RE: Proposed Change
Madison County Mississippi Circuit Court Building Renovation and Addition
Madison County Board of Supervisors
JHH No.: 23132

Re.: PN: 23132 Madison County Mississippi Circuit Court Building Renovations and Addition | PCO #3

TEMPORARY COURT FACILITIES

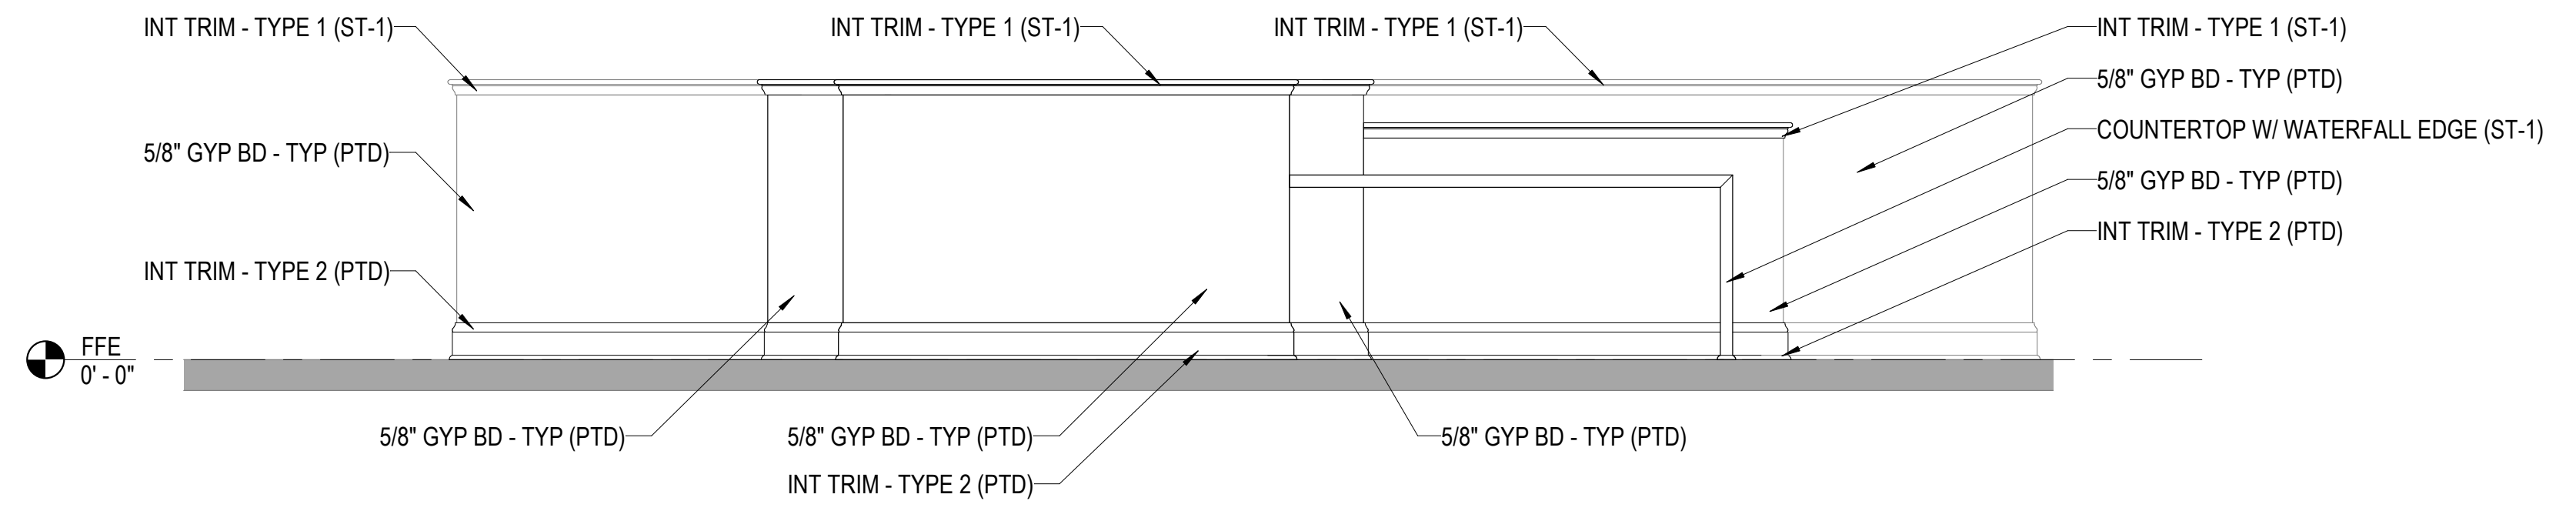
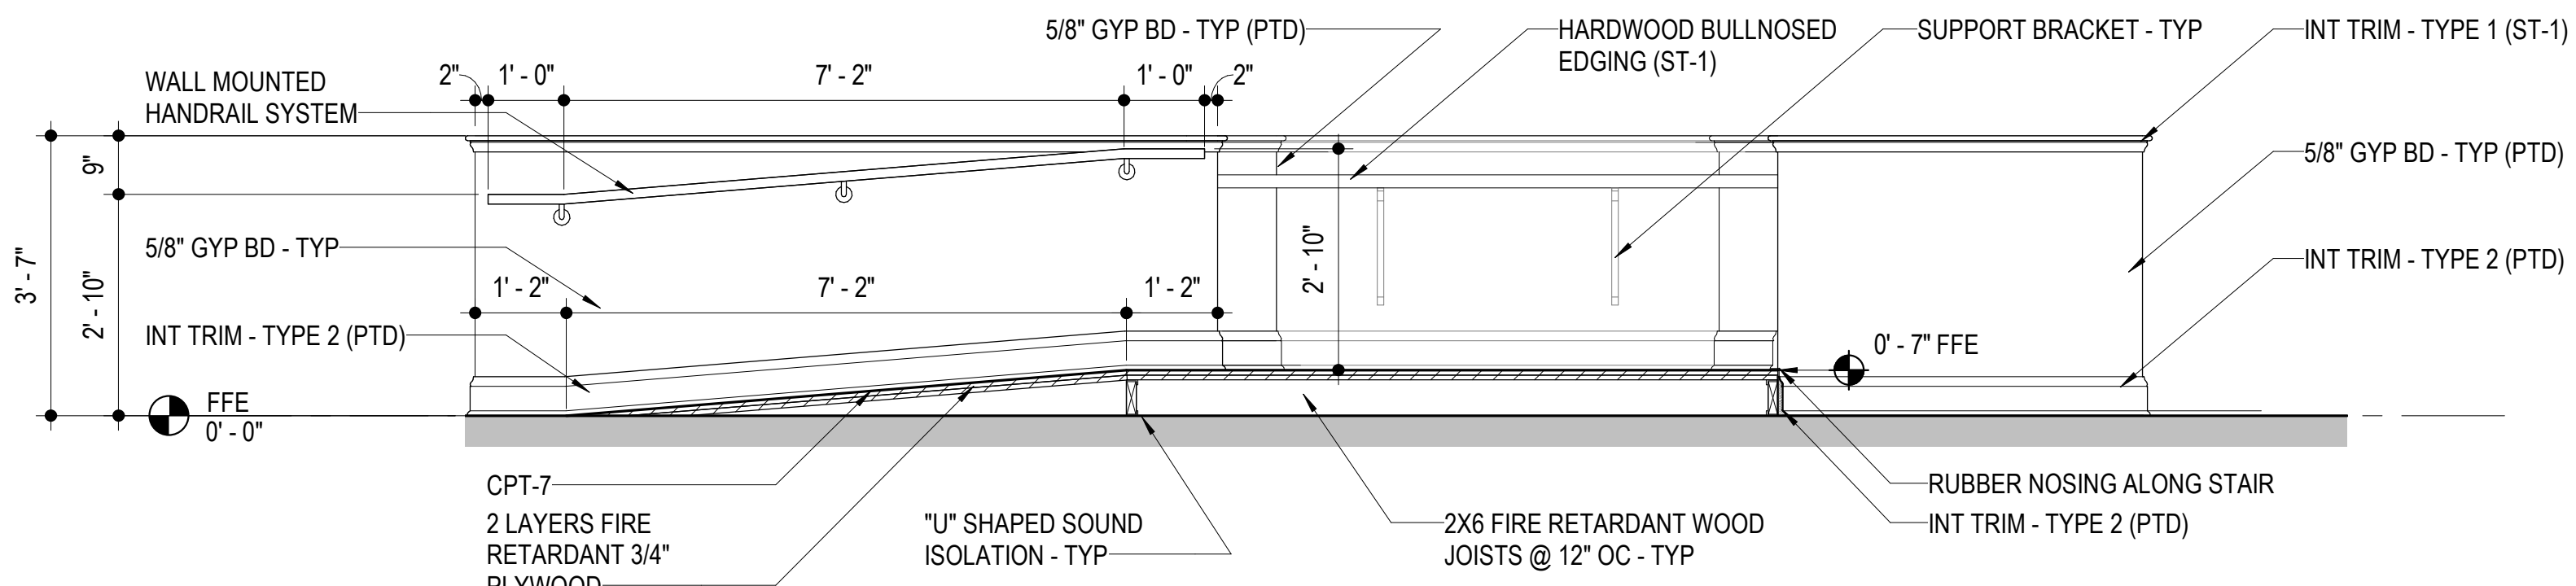
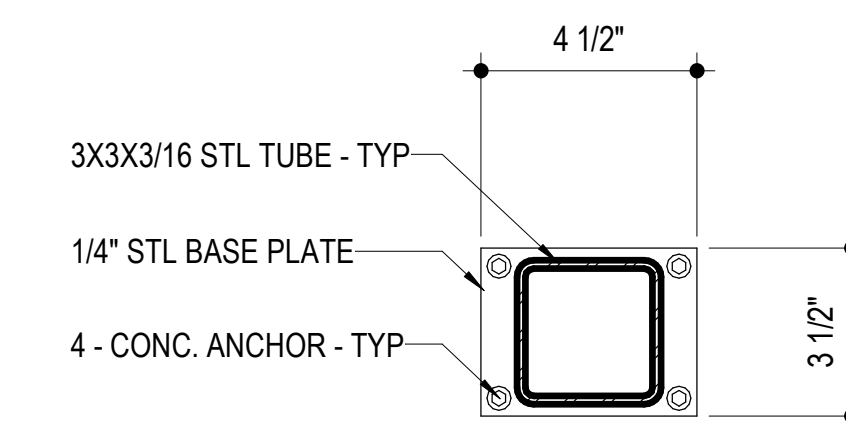
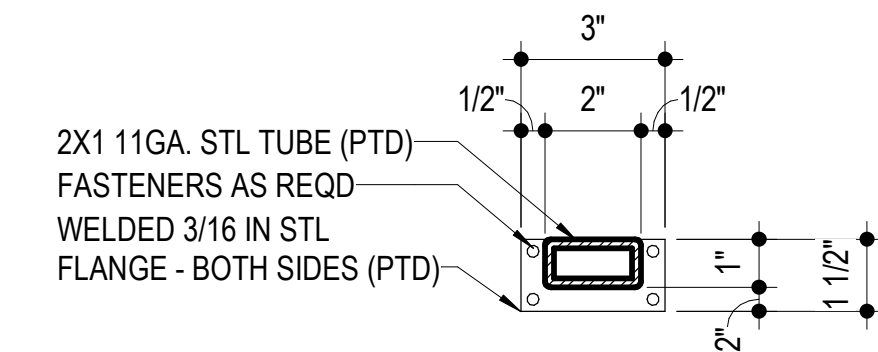
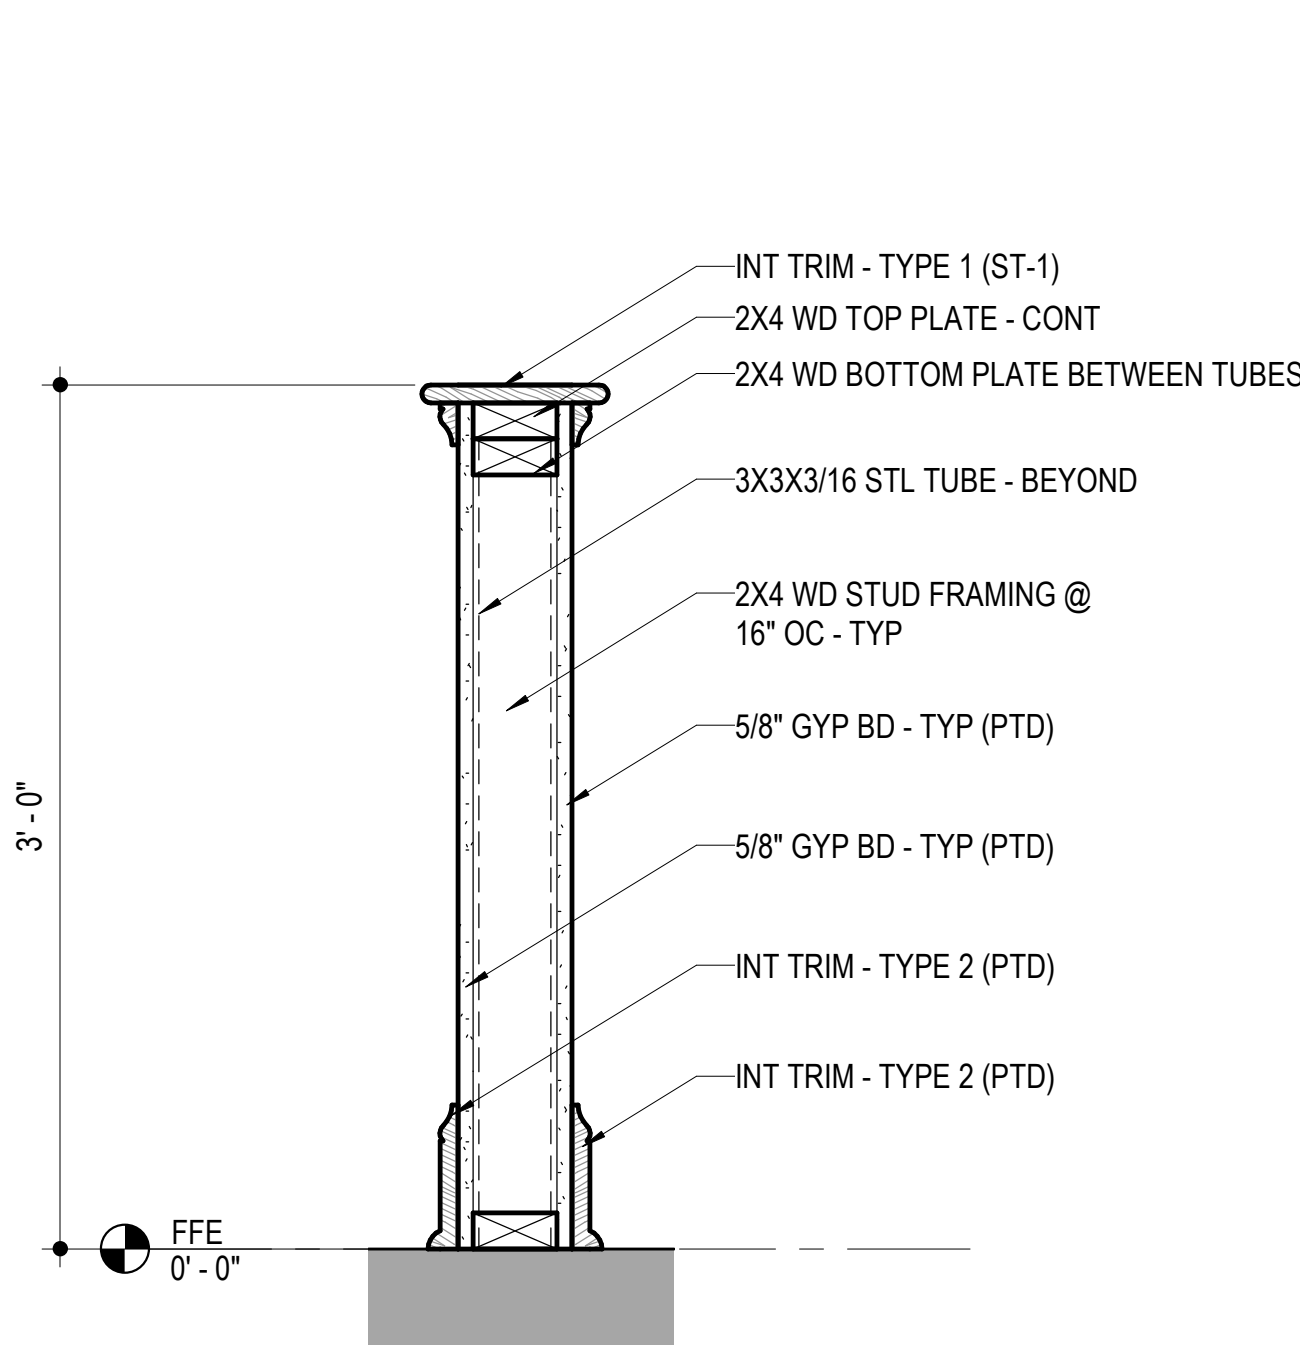
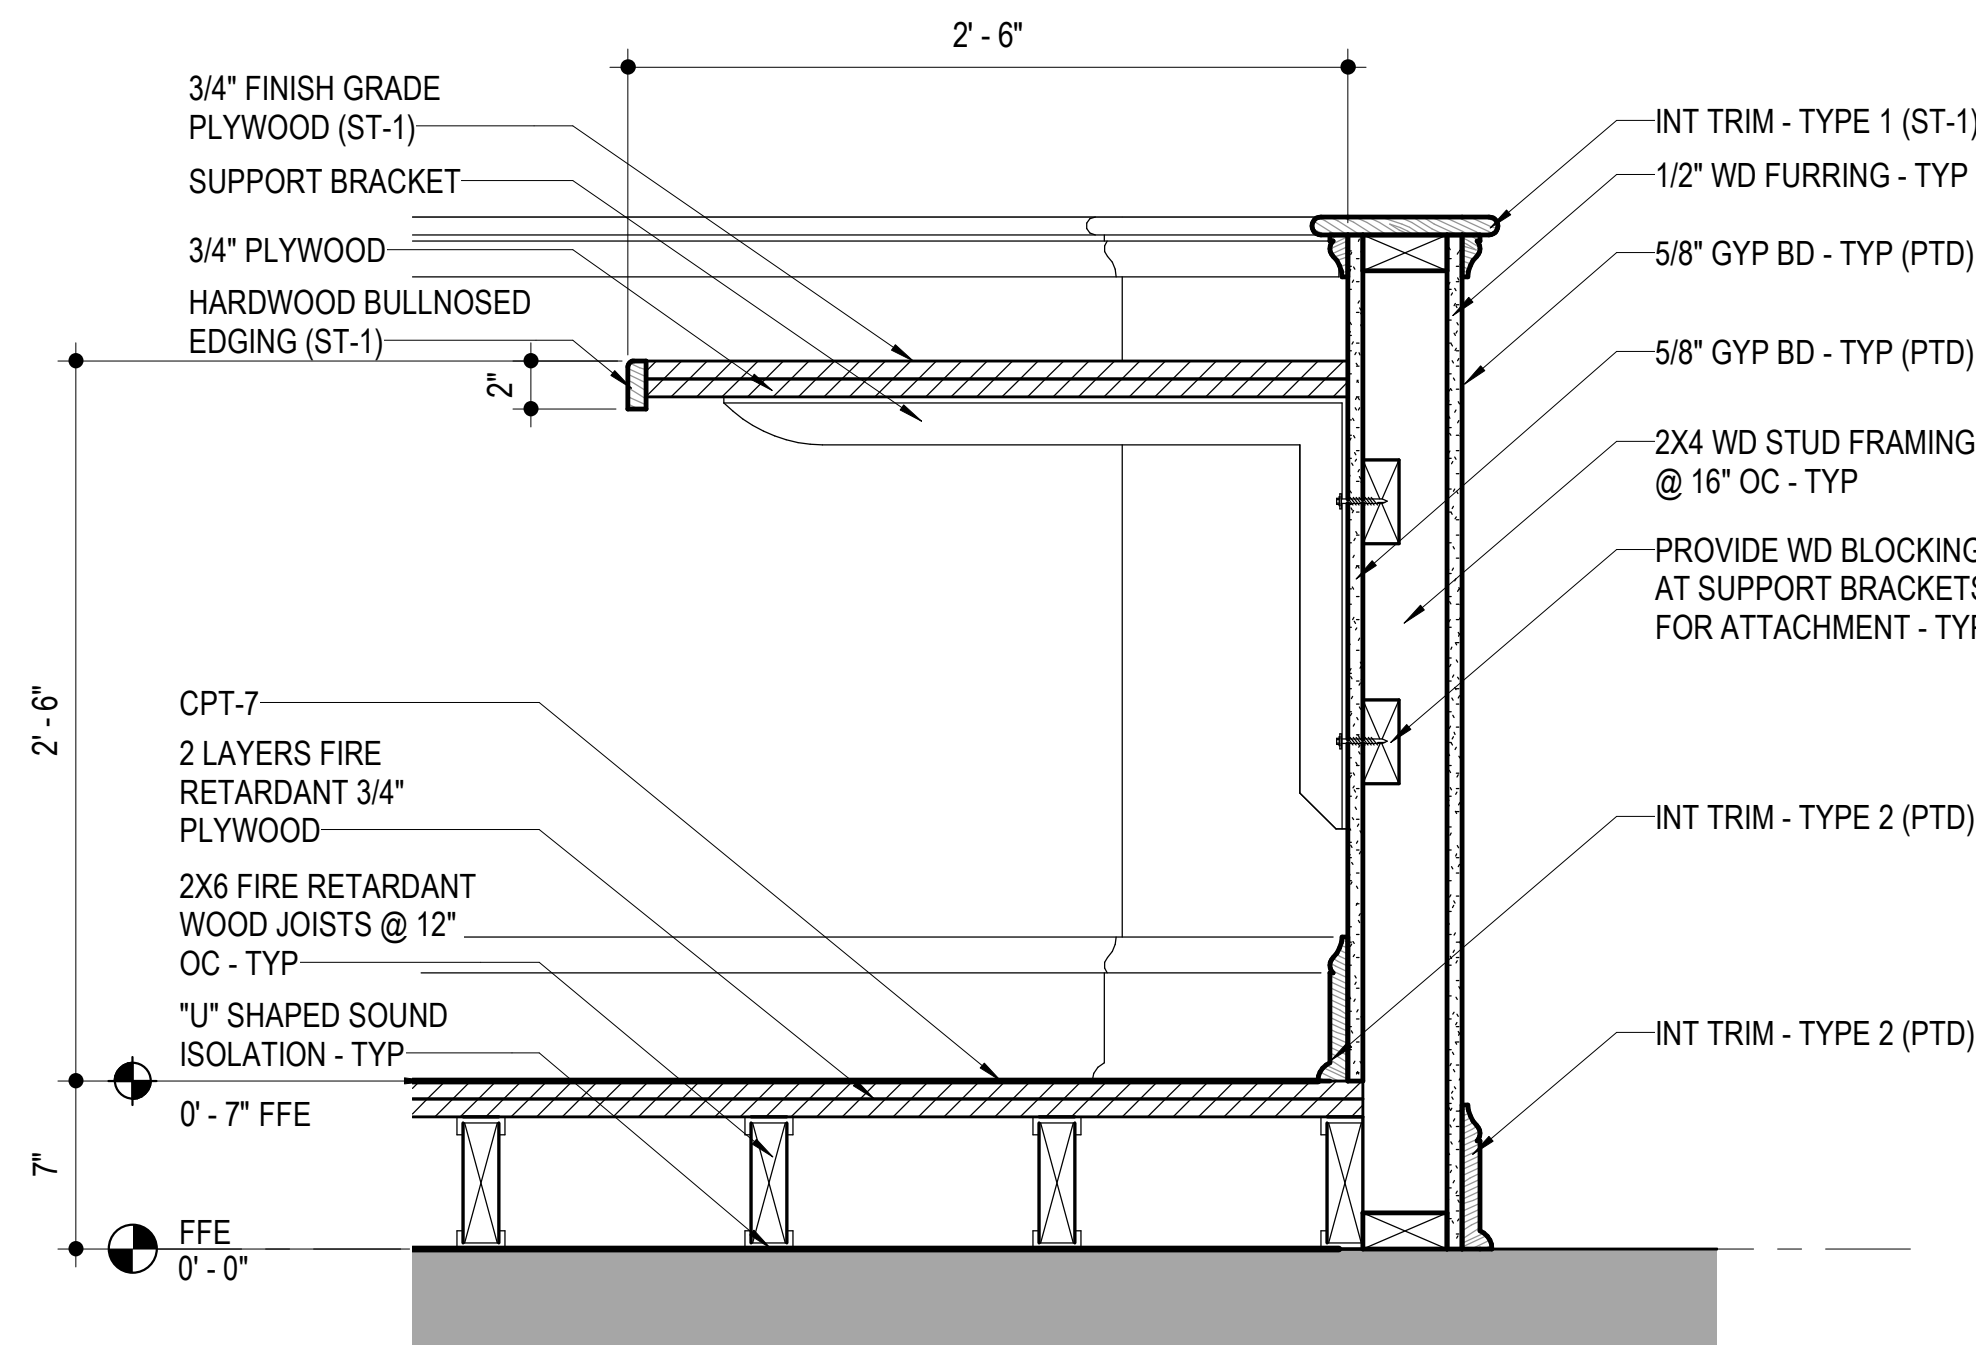
The following is the proposed change order price to provide all labor and materials necessary to complete the construction of the new Judge's Bench and Gallery Wall as shown on drawing SD.A2 dated 12/15/25. This price also includes the labor to modify the existing pews.
